NORTHEAST UTILITIES

Docket No. 50-423
B11107

Millstone Nuclear Power Station, Unit No. 3
Submittal of Responses to the Effluent
Treatment Systems Branch Draft SER Open Items

Q 460.10-1
 FIGURE 2-1-1a
 LETDOWN DEGAS
 FLOW PATH

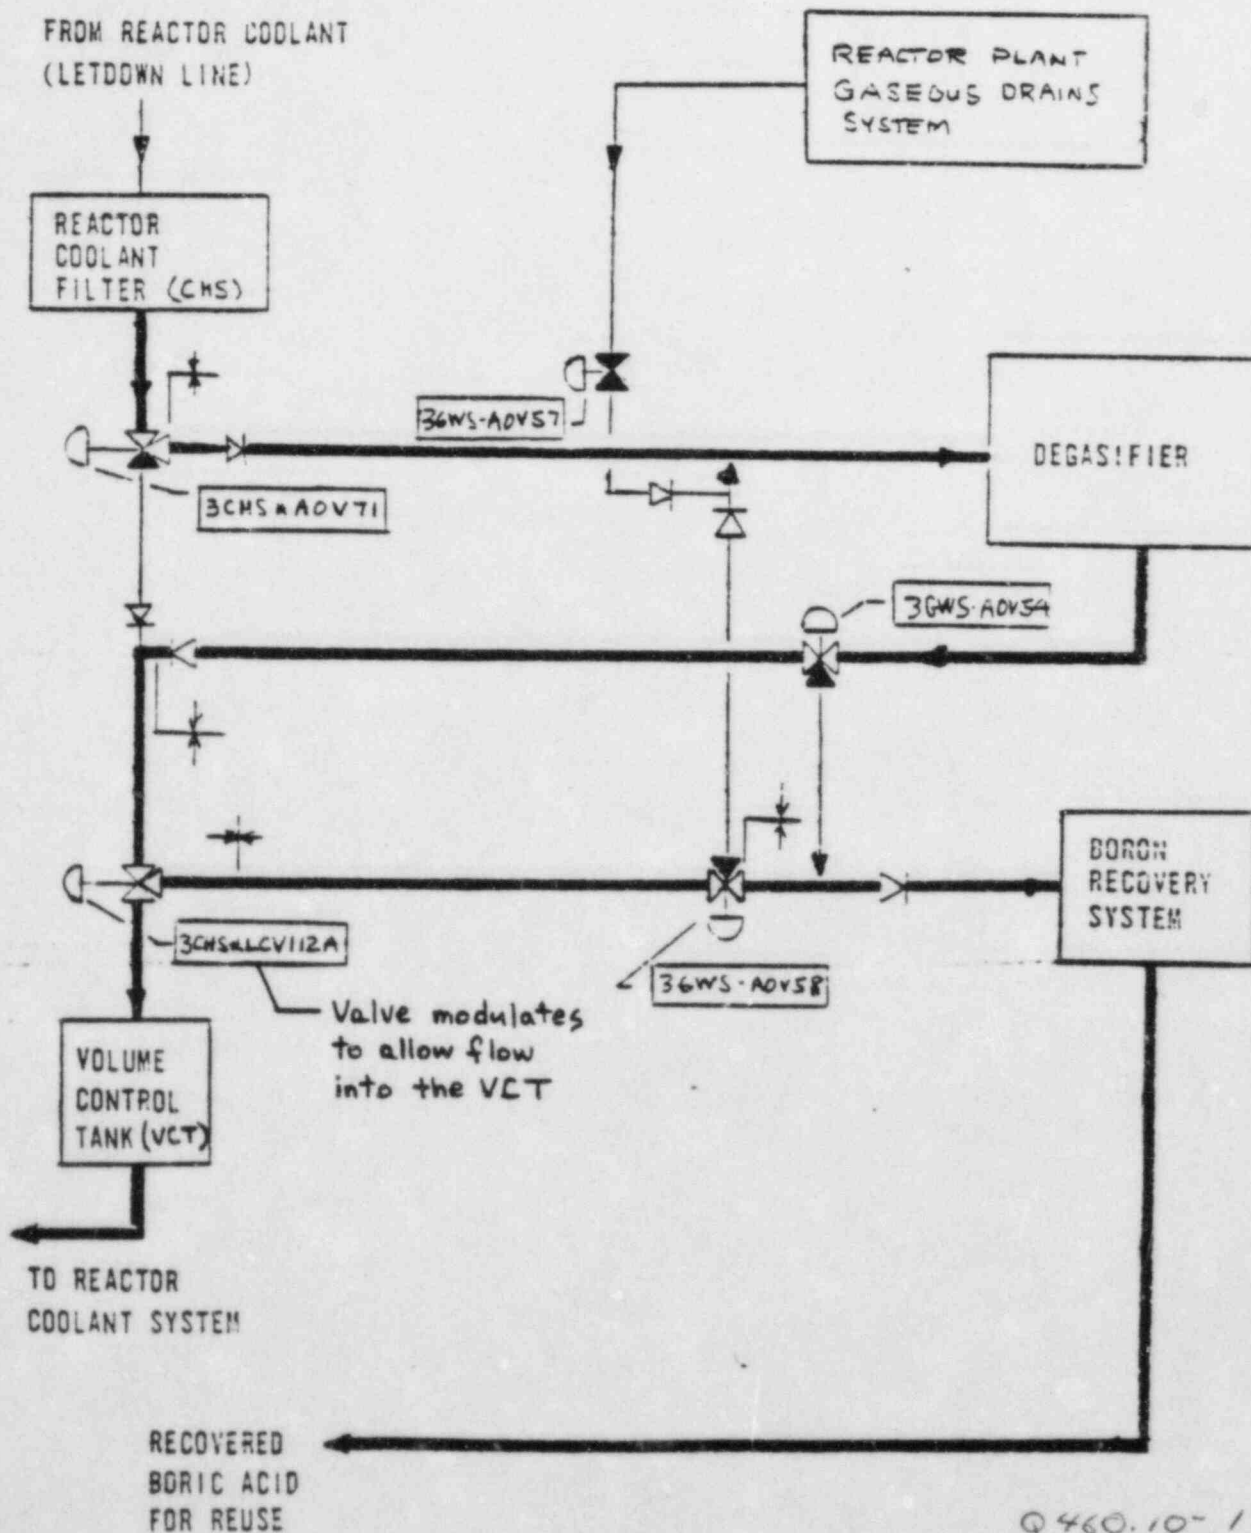
- a. Provide all possible flow directions for the four 3-way valves on the input to the BRS shown on Figure 9.3-4 (Sheet 1).
- b. Provide an analysis of 3-way valve and control failure for the valving in a. above.
- c. Describe how you plan to mitigate explosive gas mixtures of hydrogen and air in the BRS components and vents.

1. Letdown (Figure Q460.10-1)

Flow is from the RCS to the degasifier via 3CHS-AOV71, returned to 3CHS LCV112A. 112A modulates flow between the VCT and the BRS.
